10 CFR 50.90

July 23, 2010
NRC-10-0006

Subject: Response to Request for Additional Information Regarding the Proposed License Amendment to Revise the Degraded Voltage Function Requirements of Technical Specification Table 3.3.8.1-1 to Reflect Undervoltage Backfit Modification

**Response to Request for Additional Information (RAI)
Regarding the Proposed License Amendment to Revise
The Degraded Voltage Function Requirements of
Technical Specification Table 3.3.8.1-1
to Reflect Undervoltage Backfit Modification**

Internal Connection Diagram

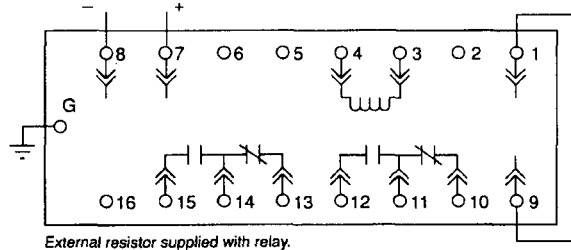
Confirm that new ABB 27N relays will provide Technical Specifications (TS) Table 3.3.8.1-1 Function 2a and Function 2b of the previous 27D relays, and that Function 2c will be provided by new time-delay (TD) relays. Also, provide catalog information for these relays, including logic drawings showing function of these new relays.

A copy of ABB bulletin 41-233S is provided in Enclosure 6, showing AC and DC connections at the relay. 125Vdc control power for the relay is provided from the existing circuit at the respective switchgear and is fed from the respective divisional batteries, as in the existing configuration. Potential transformer (PT) sensing input connections to the degraded voltage relays are also unchanged from the existing configuration, with the exception of specific terminal point designations for the ABB 27N relay. Copies of logic drawings were previously provided with Reference 3. This submittal provides updated version of several drawings. Specifically, EDP Index Items 35621.B005, B006, and B009 through B012 have been updated and are provided on a compact disc (CD).

LOCA Voltage Transient Profiles

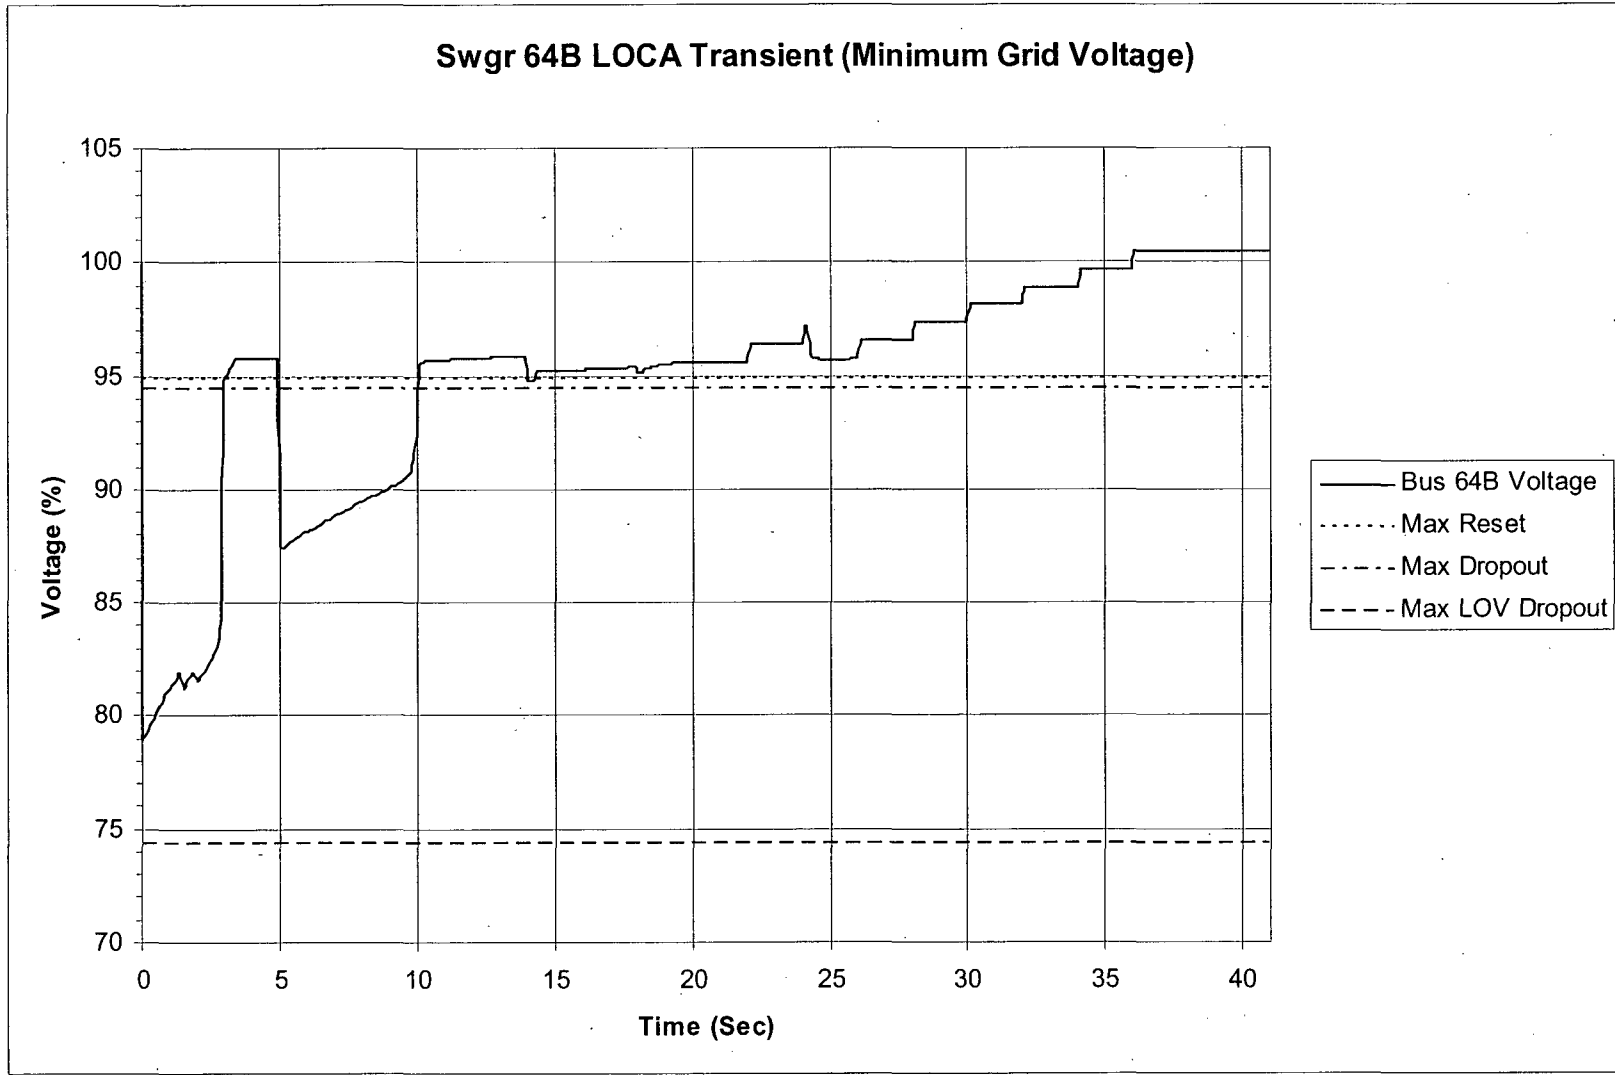
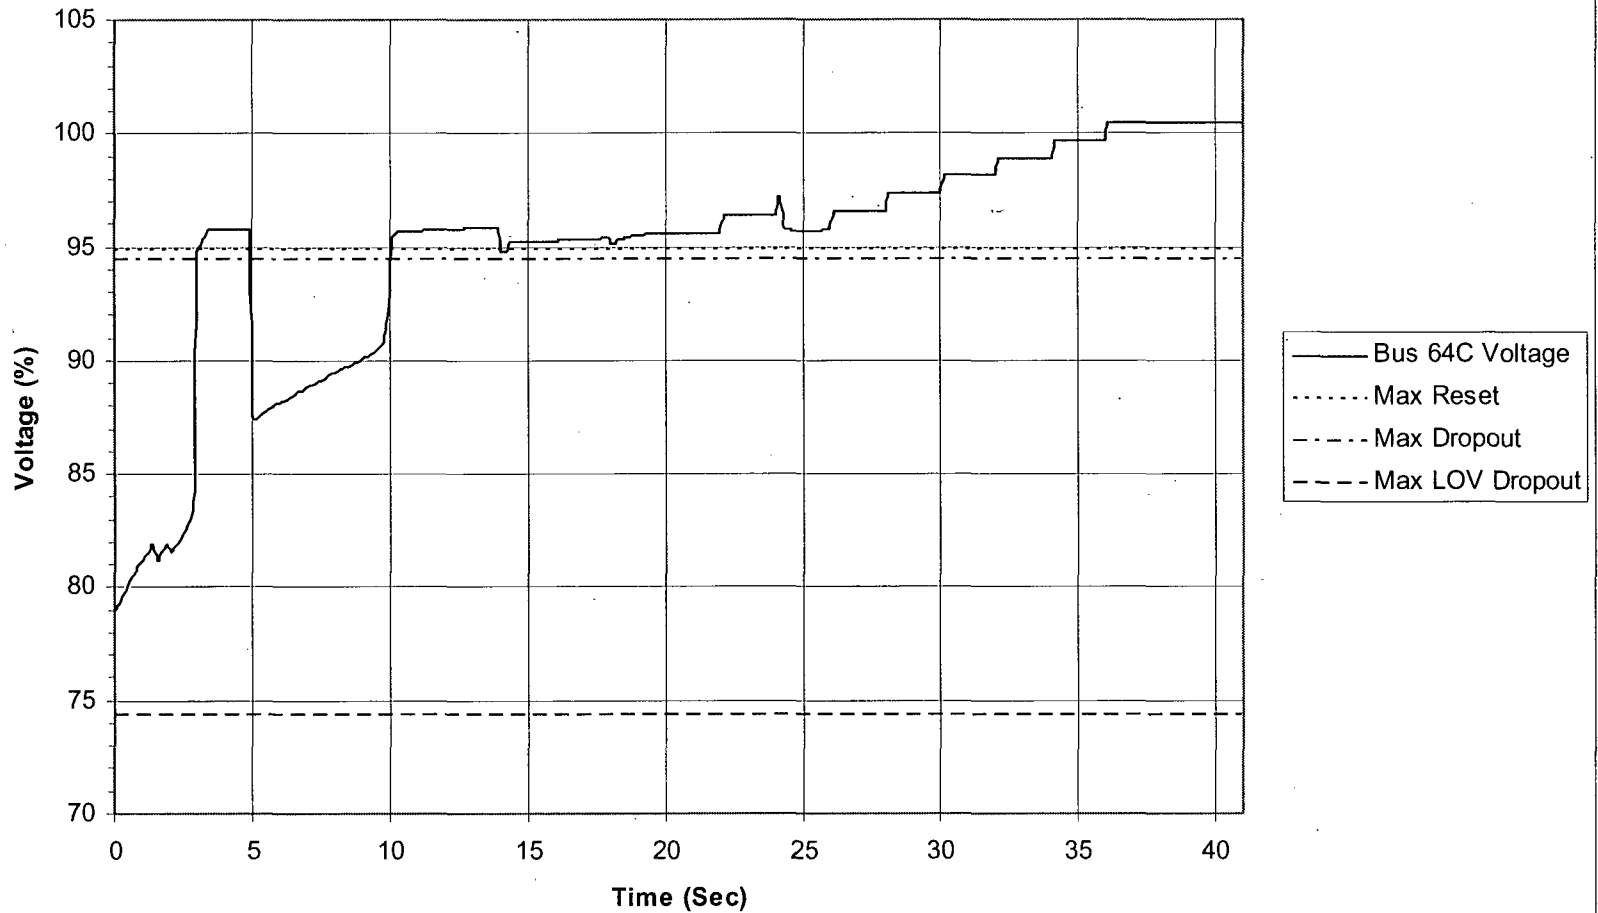
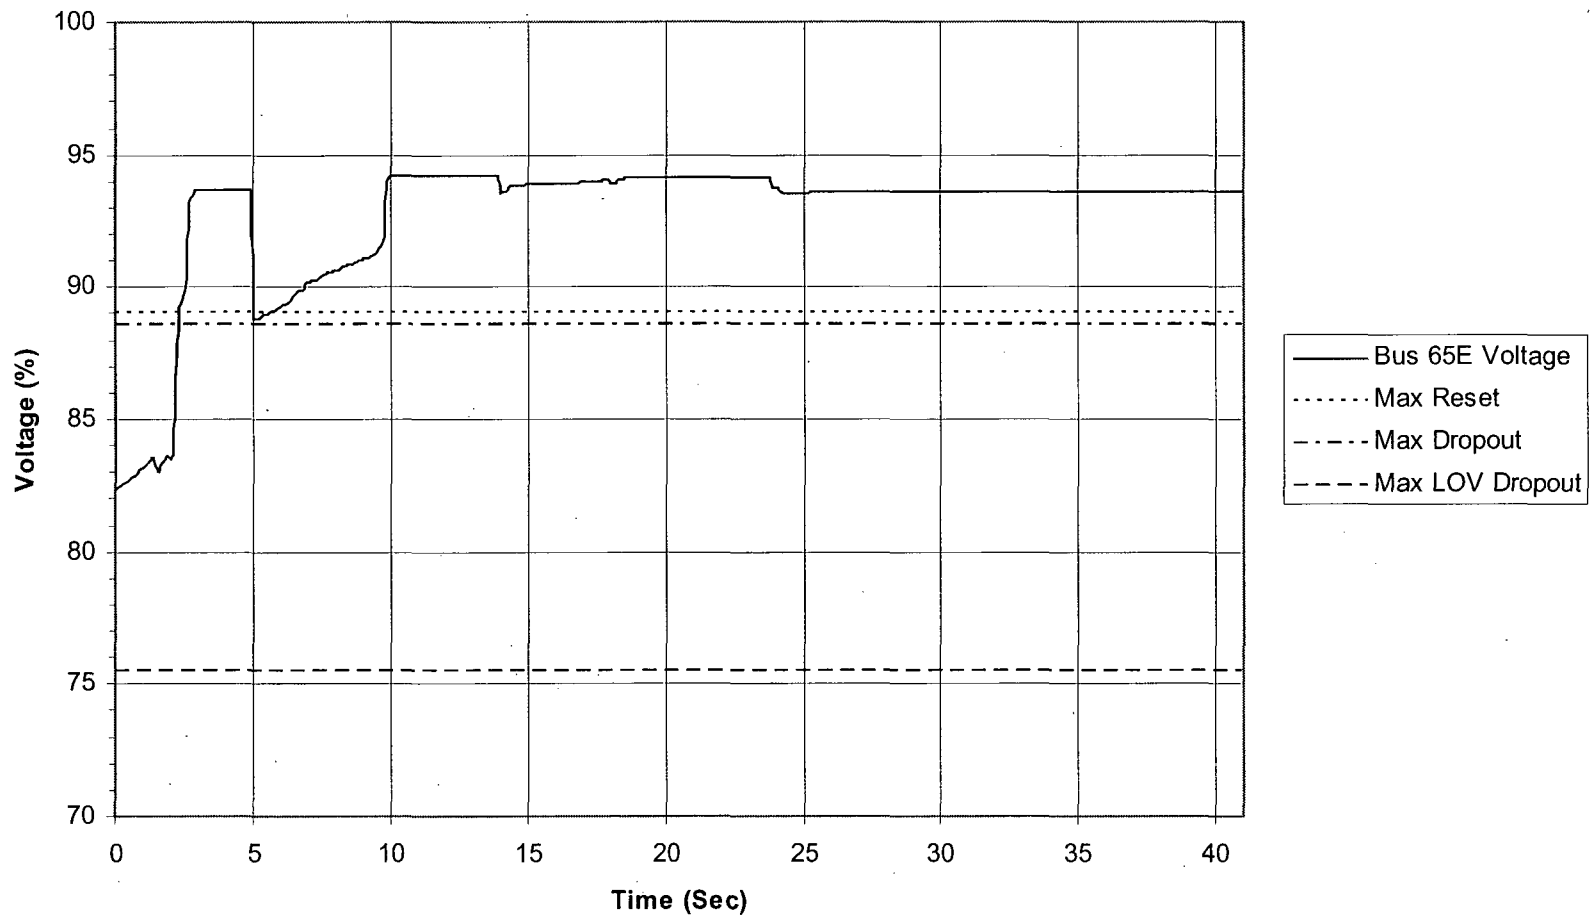
Provide summary/excerpts from the dynamic analysis, which provides the worst case voltage transient profile at the safety-related buses (those provided with degraded voltage relays) following LOCA. Preferably superimpose the characteristics of degraded voltage relays on the bus voltage transient profile to confirm that degraded voltage relays can ride through the voltage dips experienced during starting of large LOCA loads.

The reconstitution of design calculation transient analysis includes proposed changes to allowable voltage range for the 4160 volt Emergency Bus Undervoltage (Degraded Voltage) and Degraded Voltage Time Delay (with LOCA). The analysis demonstrates that for the loads in the LOCA start profile, the voltage recovers for both Divisions. This analysis also considers the starting of the 480 volt loads that receive an Auto start signal in conjunction with the RHR pump motors and Core Spray pump motors as part of the LOCA transient. The reconstituted transient analysis reflects a step voltage change associated with the trip of the of Fermi 2 main turbine generator in conjunction with the LOCA. This step voltage change is based on the annual grid study performed by the grid owner. The revised design calculation analysis that considers these items supports the modification planned for the upcoming refuel outage and demonstrates that the electrical equipment and safety loads are capable of performing their intended functions to meet the requirements of the accident analysis mentioned below.

The operational sequence of emergency core cooling systems for a design-basis accident (UFSAR Table 6.3-7) incorporates a start signal to the RHR pumps and EDGs on a LOCA signal. The Emergency Diesel Generators (EDGs) start and are ready to load thirteen seconds or less after the initial LOCA signal. If a load shed occurs in response to a degraded voltage relay trip, the time period from the initiation of the LOCA signal until EDG breaker closure (and RHR pump restart) can be up to thirteen seconds and remain within the accident analysis. In addition, as stated in the UFSAR, the accident analysis associated with loss of alternating current power (UFSAR Section 15.2.6) indicates that the estimated time for the EDG breakers to close is thirteen seconds after the loss of offsite power. The reconstitution of the design calculation transient analysis indicates that this accident analysis is met.
